Planning Commission Staff Report

Project Type:	Ordinance Amendment
Meeting Date:	December 13, 2021
From:	Chris Dietz, Planner 
Location:	17519 Chesterfield Airport Road
Description:	<u>P.Z. 14-2020 84 Lumber (17519 Chesterfield Airport Road)</u> : An ordinance amendment to modify development criteria contained in City of Chesterfield Ordinance 2575 which established a “PC” Planned Commercial District on a 7.42-acre tract of land located at 17519 Chesterfield Airport Road (17U510073).

**Re: P.Z. 14-2020 84 Lumber – Ordinance Amendment – Issues Letter
Response**

Figure 4a: Previous Arnage Access Exhibit

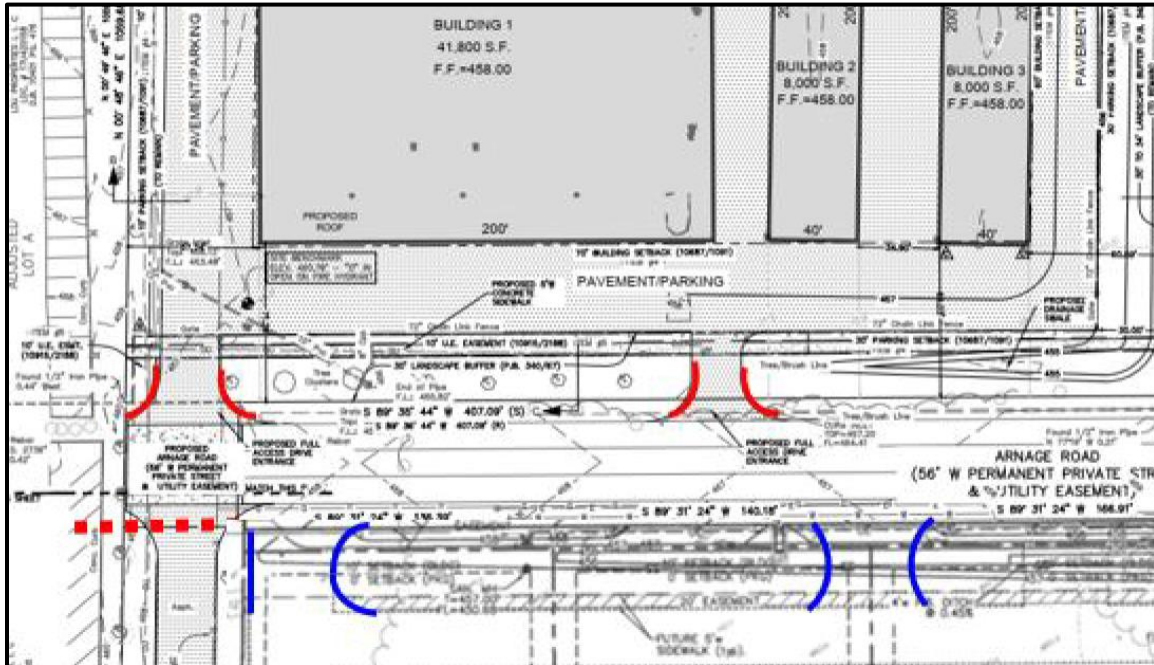
Issue: A Traffic Impact Study was included in the request to provide analysis on the impact of retaining access to Chesterfield Airport Road. An issue was raised regarding the Site Development Concept Plan for the TSG Chesterfield Airport Road subdivision directly south of Arnage Road. Staff instructed the applicant to provide detail on how the proposed access points to this site will comply with the UDC’s access management standards and avoid conflict with the proposed access points south of this development:
